STATE OF HAWAII
DEPARTMENT OF TRANSPORTATION
HIGHWAYS DIVISION

ADDENDUM NO. 1
for
KAMEHAMEHA HIGHWAY
KAIPAPAU STREAM BRIDGE REPLACEMENT

FEDERAL AID PROJECT NO. BR-083-1(48)

TEMPORARY 16–INCH WATERLINE CONNECTION PLAN (PHASE 2)

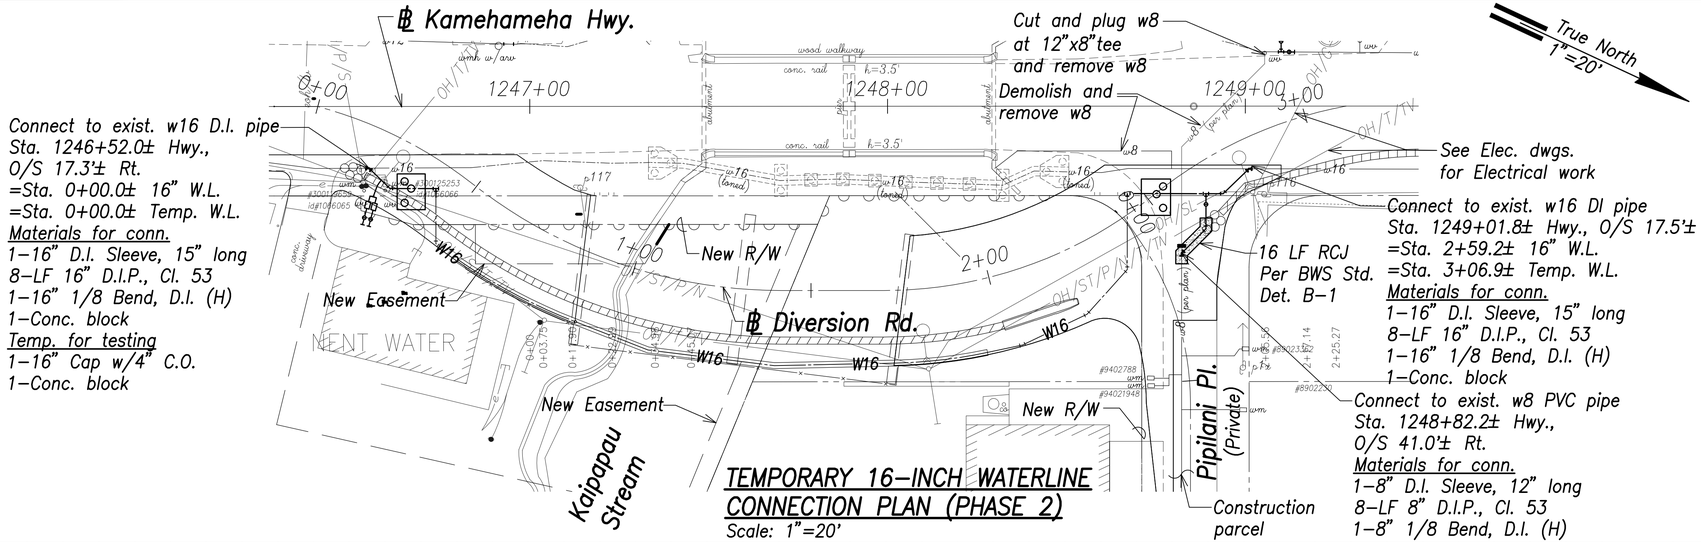
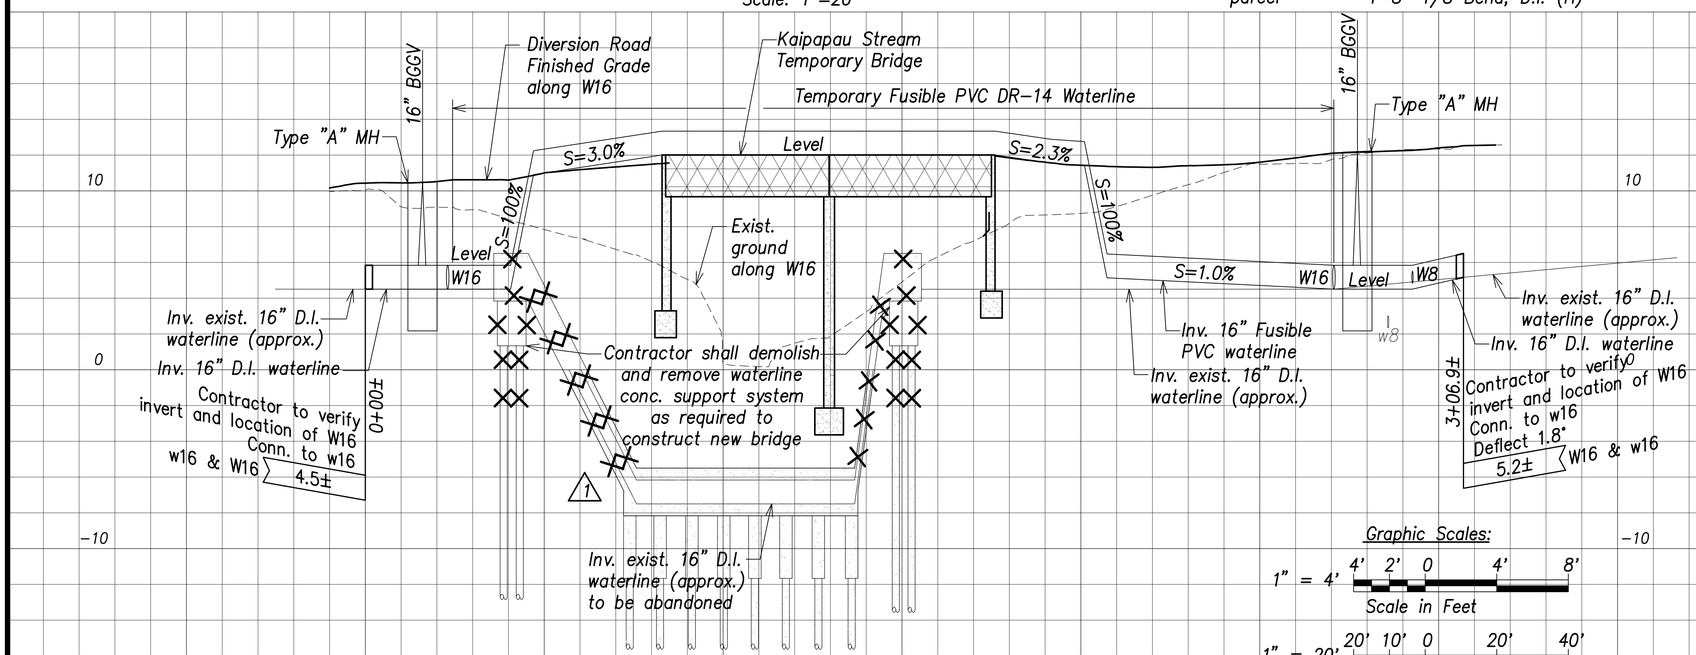
7. Please provide limit of removal for the 16" Waterline in the stream. Phase 2 on Sheet C-31 shows to remove 16"WL all the way down to the bend. Sheet C-33 shows to remove 16" waterline down to Elev +2.

Response: Sheet C-33 has been revised to show exist. 16" waterline to be removed down to the bend. The revised Sheet C-33 has been included in Addendum No. 1.

FED. ROAD DIST. NO.	STATE	PROJ. NO.	FISCAL YEAR	SHEET NO.	TOTAL SHEETS
HAWAII	HAW.	BR-083-1(48)	2021	39	161

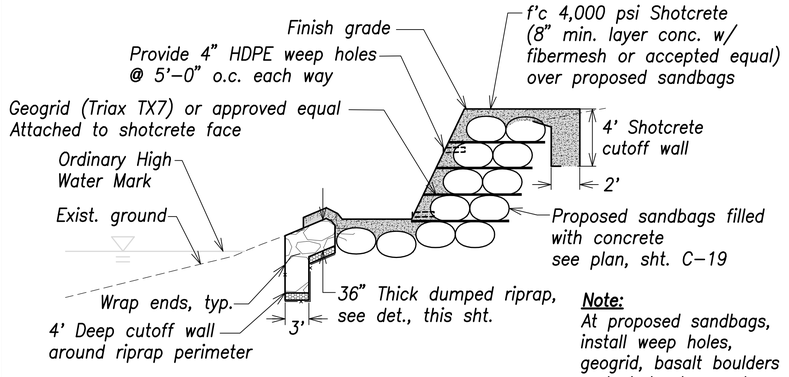
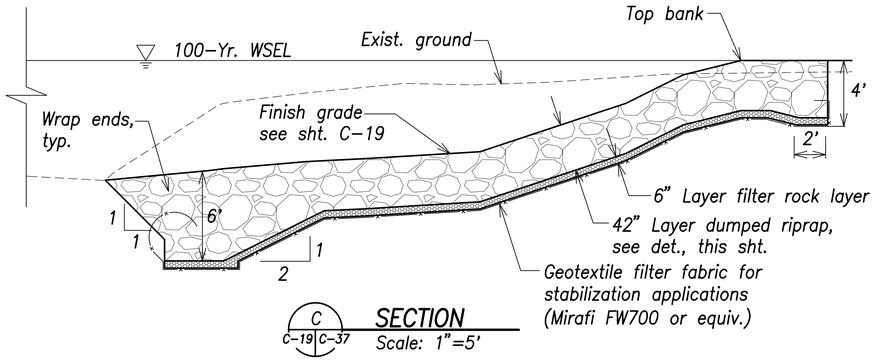
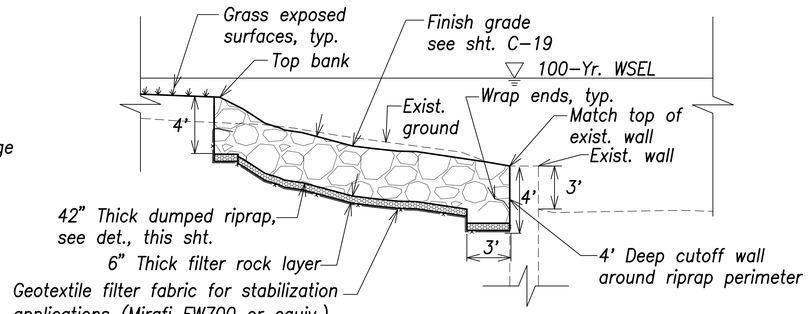
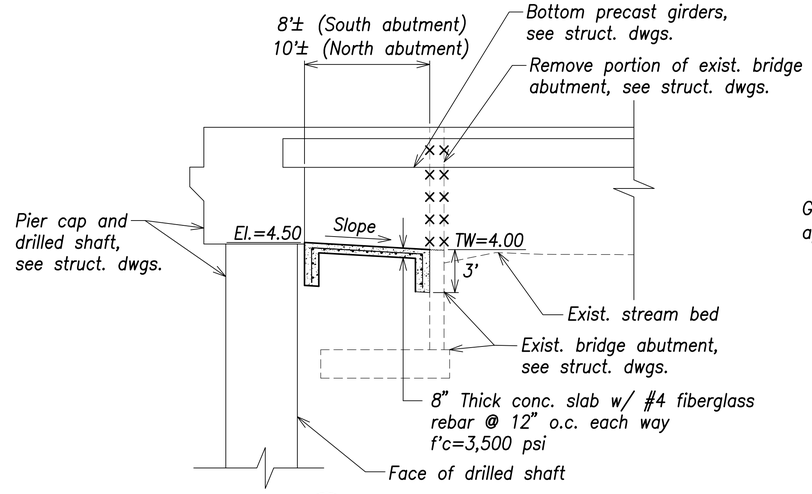
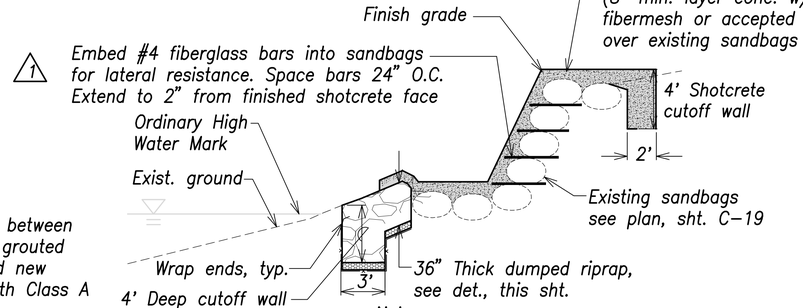
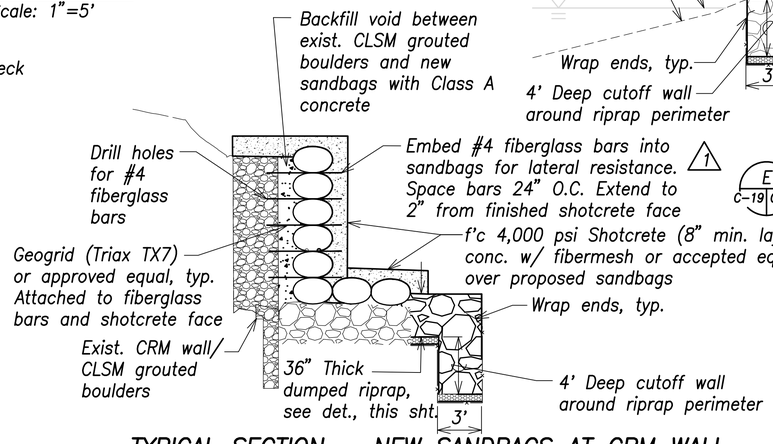
5. Sheet C-37: Please provide the on center spacing of the #4 fiberglass bars.

Response: The spacing shall be 24" on center. Sheet C-37 has been revised to show this and has been included in Addendum No. 1.
